December 09, 2022 City of Albuquerque Building and Safety 600 2nd St NW, Albuquerque, NM 87102

RE: DRB Project Number: 2021-006261

I am in receipt of comments provided on 12/06/2022 and have provided the following revisions, responses to those comments:

Project: GRIEGOS FARMS Phase: SD

C - 300

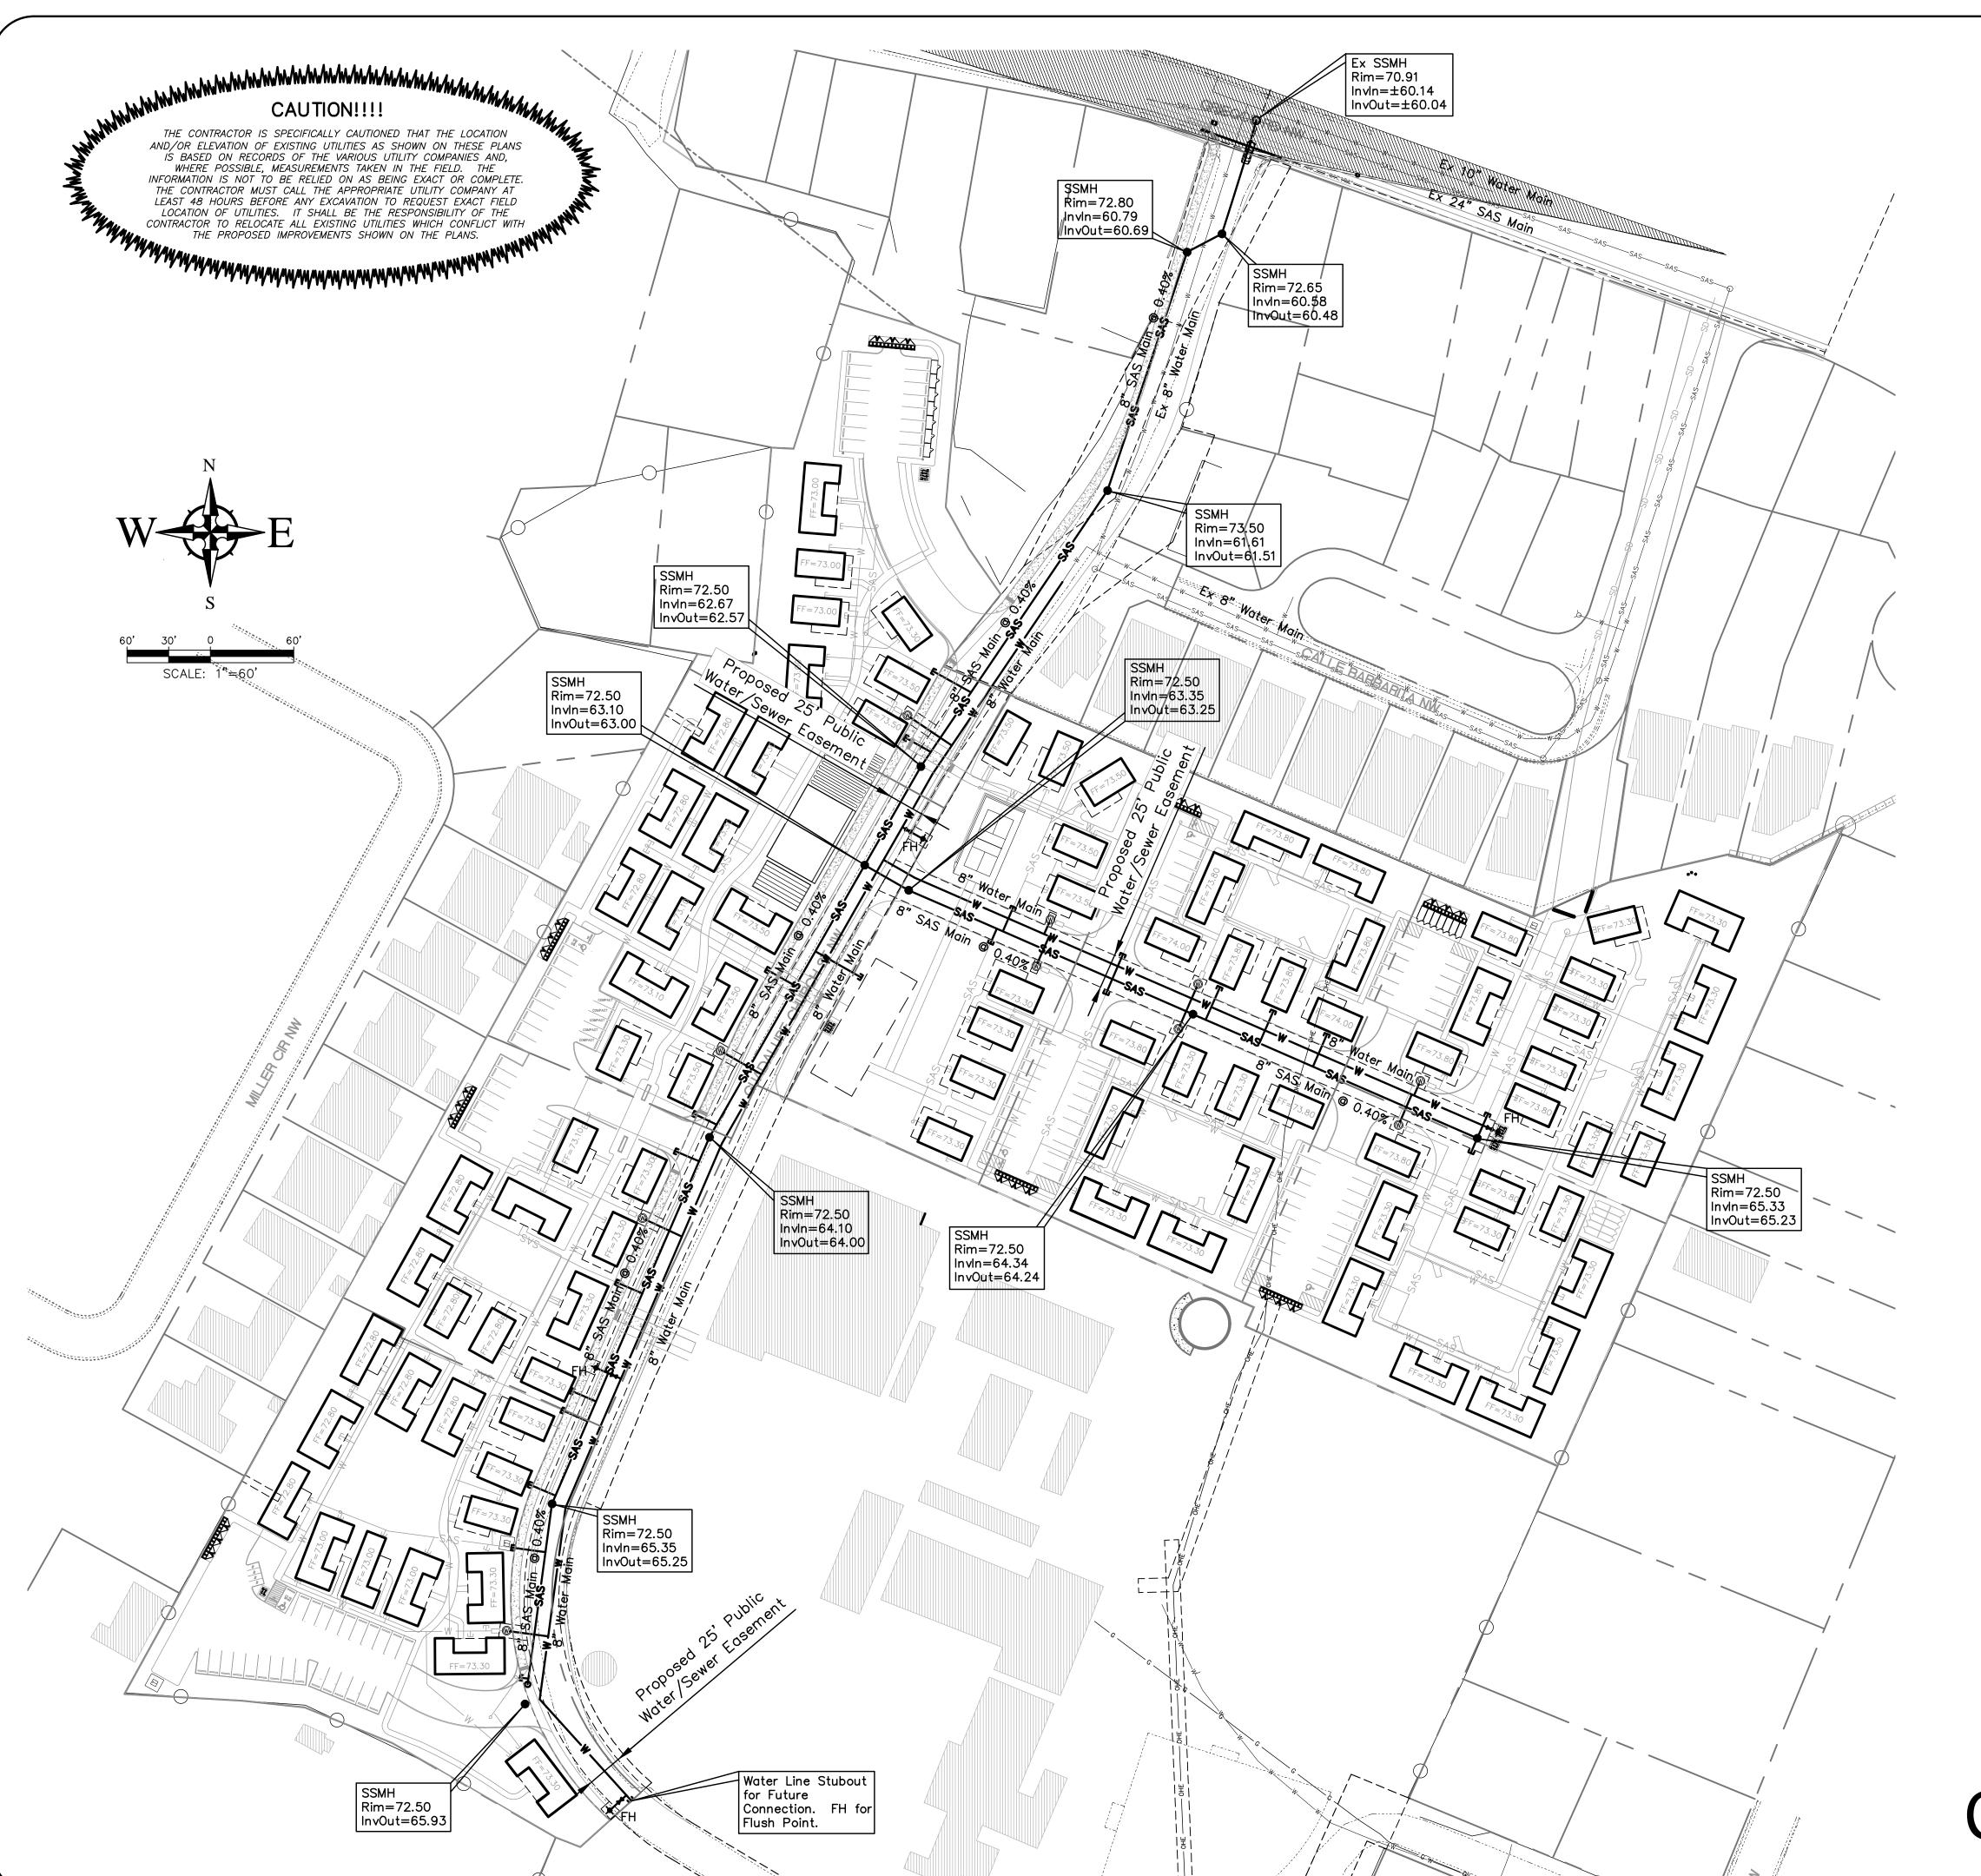
- 2. Please provide easement widths.
 - Response: Proposed easement widths have been called out on the Utility Plan.
- 3. Update site plan to show the additional waterline loop.

- 4. Please clearly label public and private infrastructure.
 - Response: The Utility Plan has been updated graphically to better reflect the public/private lines. David Gutierrez has reviewed and approved the attached revised Utility Plan.

- 5. Show all proposed meters and clearly label private water infrastructure as well to delineate ownership. Response: The Utility Plan has been updated graphically to better reflect the public/private lines. David Gutierrez has reviewed and approved the attached revised Utility Plan.

- Response: Per our discussion with David Gutierrez, we do not currently have any easements in order to loop the proposed water system and the Utility Plan is approved as-is per the current Availability Statement. We will investigate the possibility of providing a loop through the church property but cannot guarantee that we will be able to obtain the necessary easement.

LP103

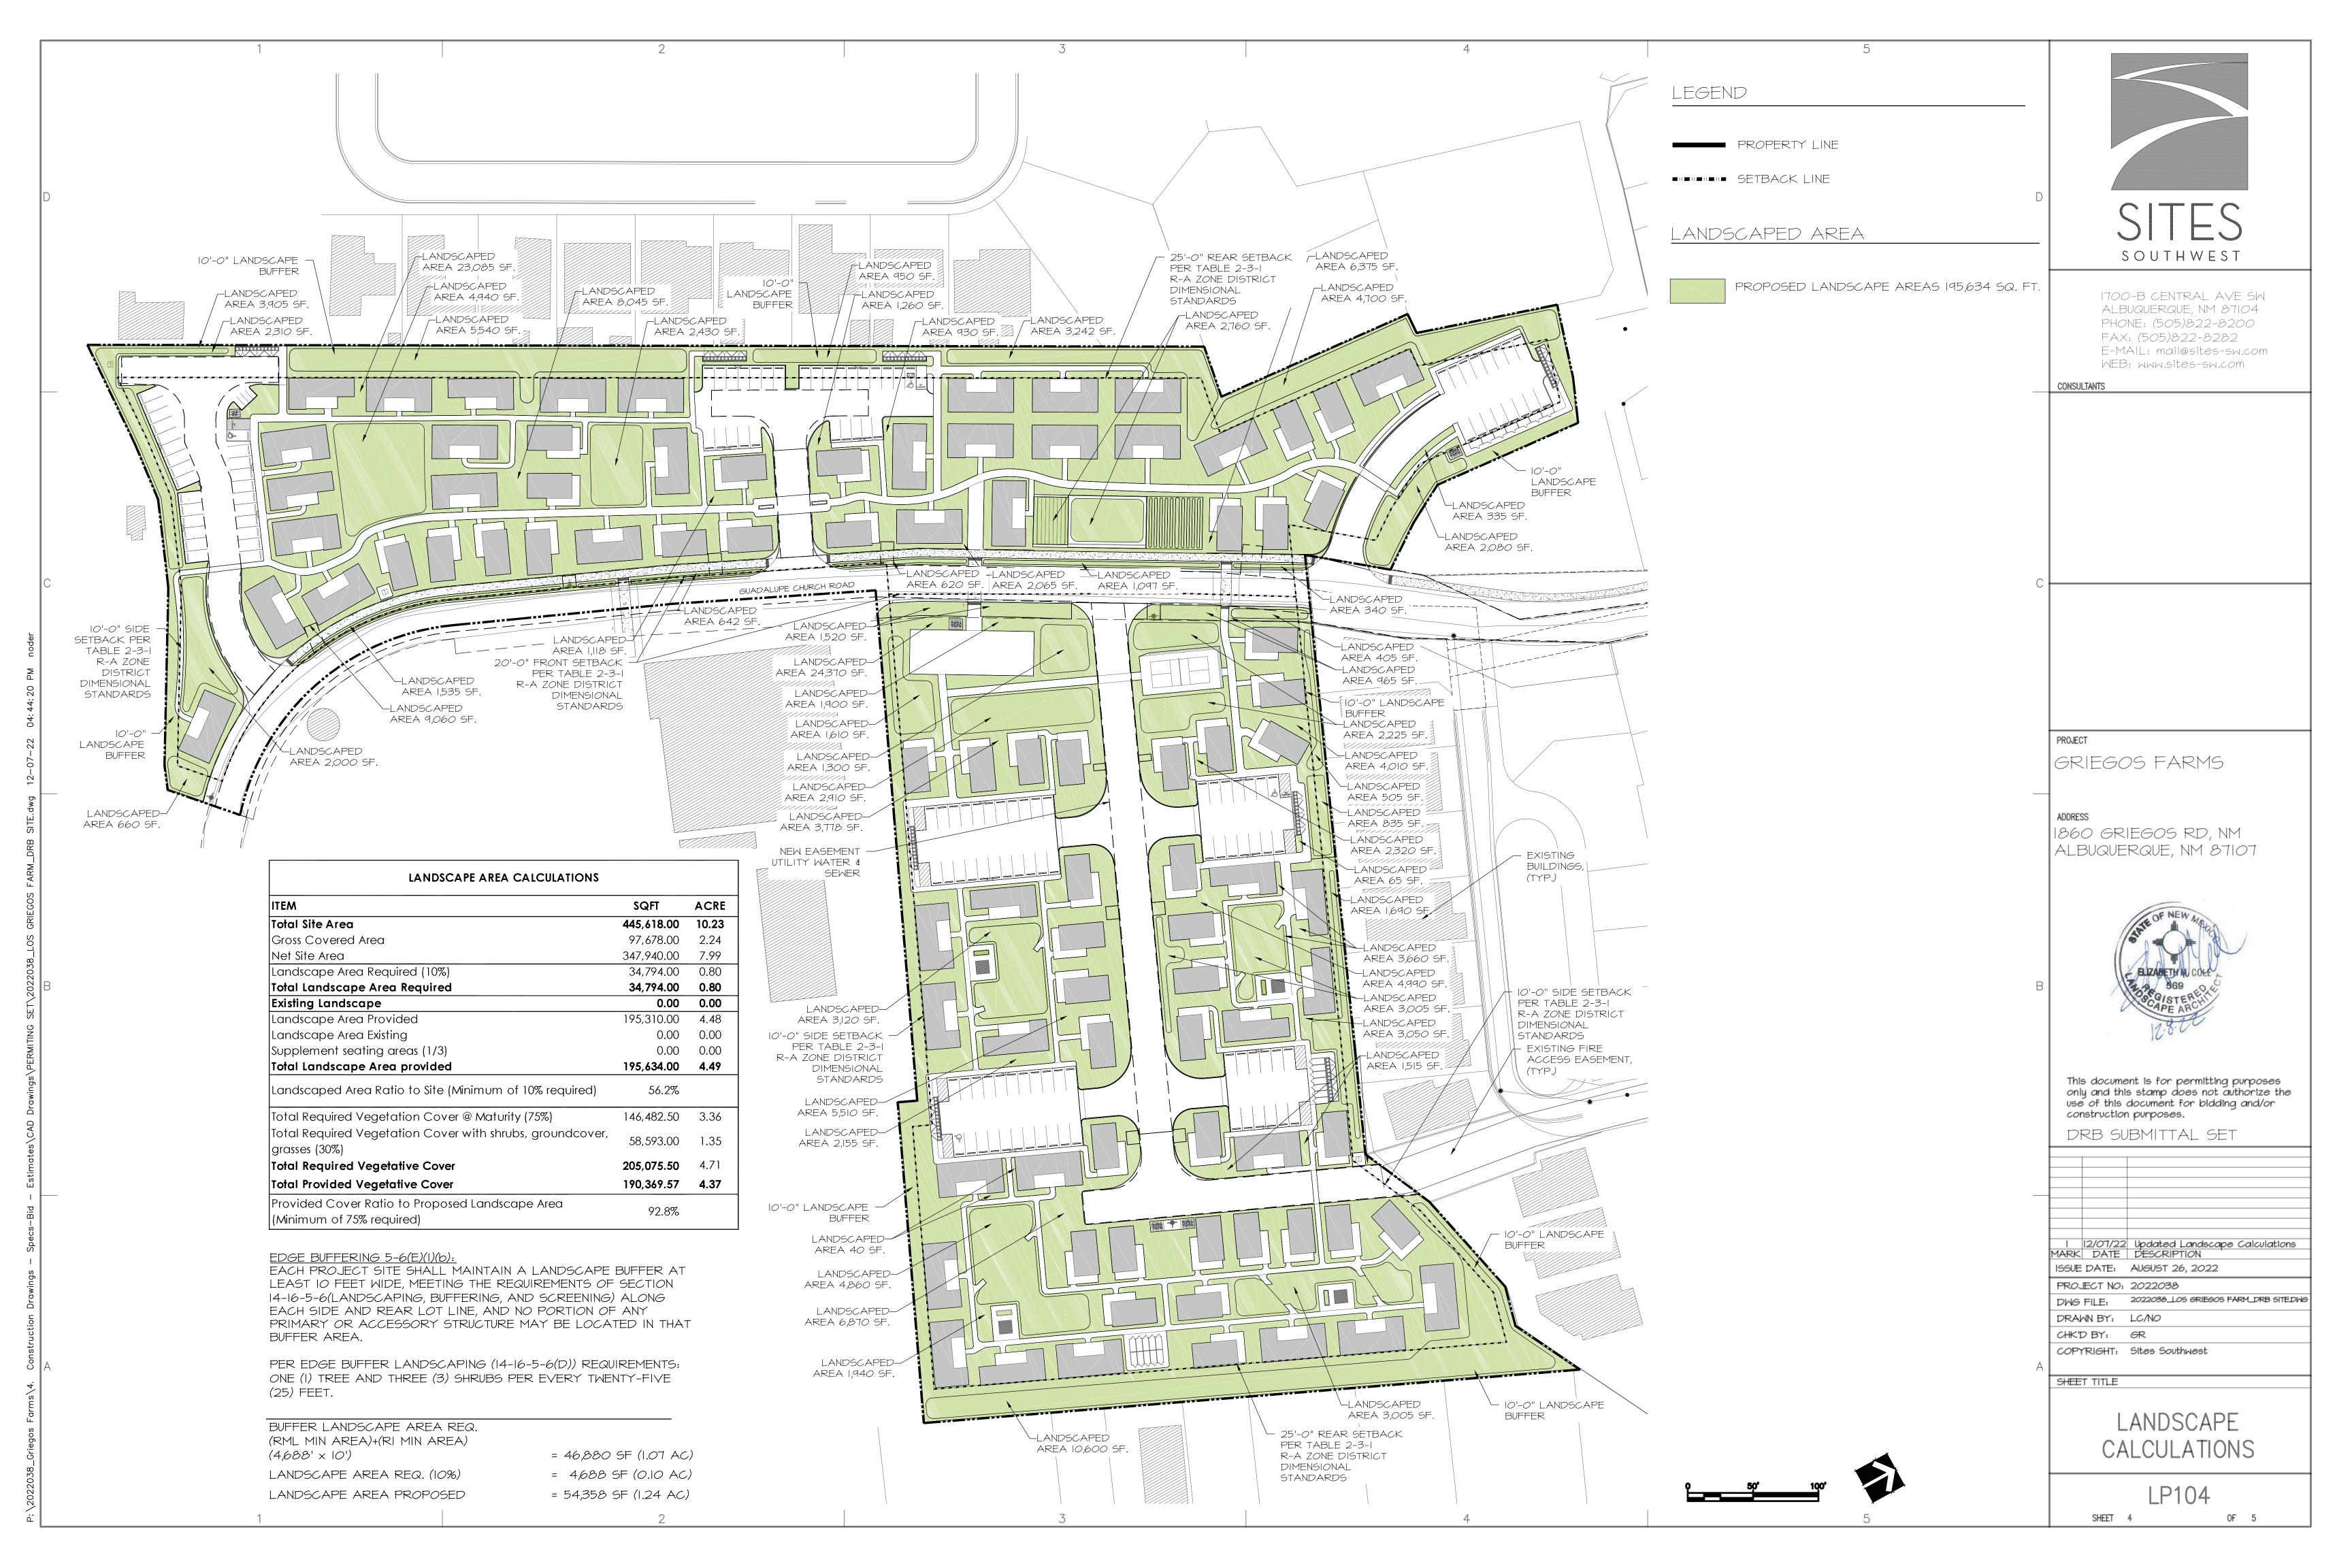
11. The project site has a 10-foot buffer or greater along each side and rear lot line. Please confirm that the all the landscape buffers are landscaping.

12. Please confirm how this 30 % usable open space requirement is being met. The landscape plan shows 126,636 s. f. of landscape area. The landscape area can count as usable open space as can the areas highlighted in yellow below.

Response: All landscape buffers are landscaping as indicated on sheet LP03 and confirmed through calculations sheet LP104. No structures are proposed in this landscape buffer.

Response: Landscape plan shows a total of 195,634 sf. of landscape area provided per sheet LP104 Landscape area Calculations.
